Refer to: NIS:REK-71-298

Subject: Additional Information - Processing  
Yankee Reload Fuel SNM-777, Docket 70-820

E-302863-4 Modification for Yankee Fuel Rods

DRESDEN CORROSION  
RACK - E-302863

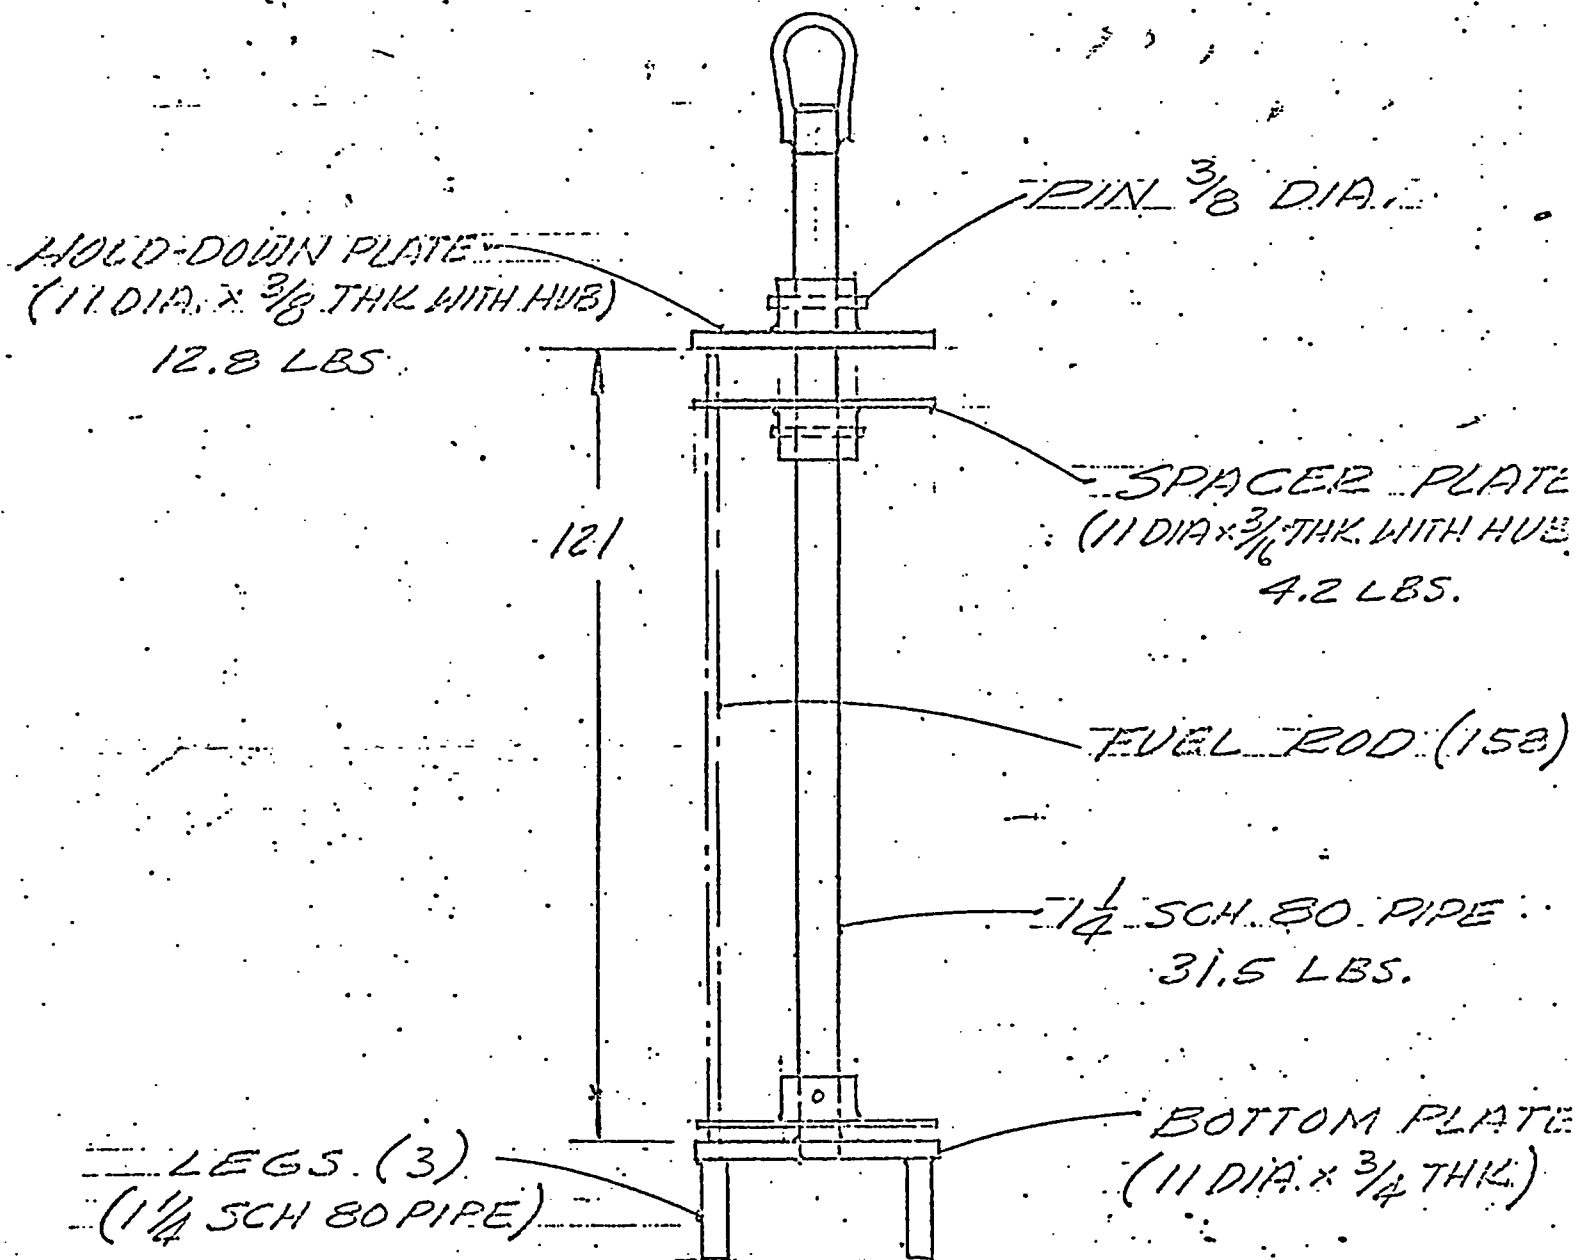
Corrosion rack must retain fuel rods within original safe geometry in the event the rack is dropped from any crane in building 24-D. The maximum height of drop would be 20 feet and could only occur within an autoclave, which would guide the rack so that it could only land on its bottom supporting legs. The autoclave would also prevent the possibility of the rack falling on its side after impact.

Fuel rods would remain within safe geometry providing holddown plate would remain in position after drop. Holddown plate is secured in main structure by means of a 3/8 inch diameter stainless steel pin. Criteria of failure is based on shearing of pin (maximum allowable shear stress =  $.75 S_t$  maximum = 67,500 psi) as a result of force developed in drop. Calculations are based on rack and legs stopping simultaneously while upper portion of rack continues downward with fuel rods, absorbing energy through elasticity of fuel rods and center pipe only. The cushioning effect of the fluid in the autoclave is neglected.

We find the corrosion rack to be structurally safe based on the following calculations:

DRESDEN CORROSION  
RACK - AS REVISED FOR USE  
WITH YANKEE RODS E-302863-4  
ALL STAINLESS STEEL CONST.

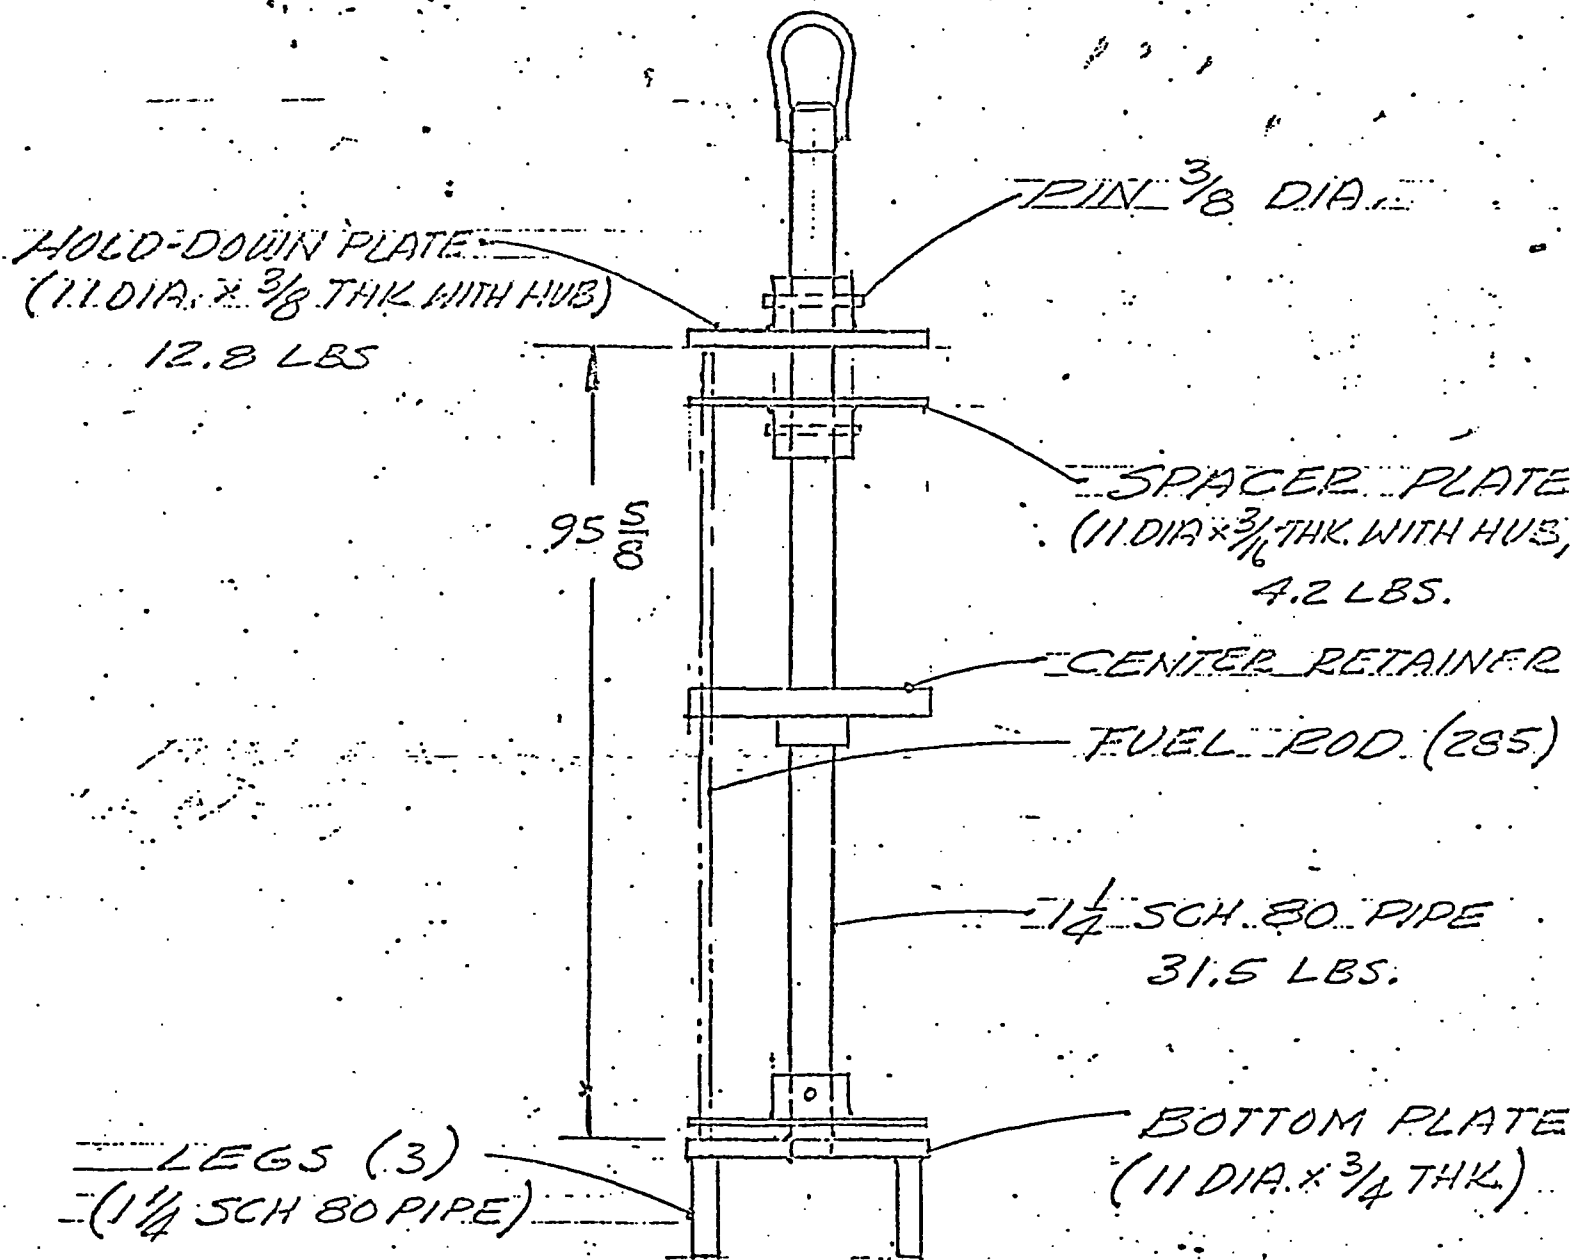
Included with this additional information is revised drawing E-302863-4 which shows an added inner portion of the safety ring. This ring is also shown on the sketch of the fixture as used with Yankee Reload fuel. The modified safety ring precludes the bending of rods into the center void portion of the fixture.

The rack, as modified, will hold 285 Yankee rods at 3.16 lbs. each. The weight of the rods will be 901 lbs. compared with 1,434 lbs. for 158 Dresden rods.

Since the rack has been shown to be structurally safe for the 158 Dresden rods, it will be structurally safe when loaded with 285 Yankee rods.

CPD recommends structural approval for 285 Yankee rod loading for corrosion rack E-302863-4.
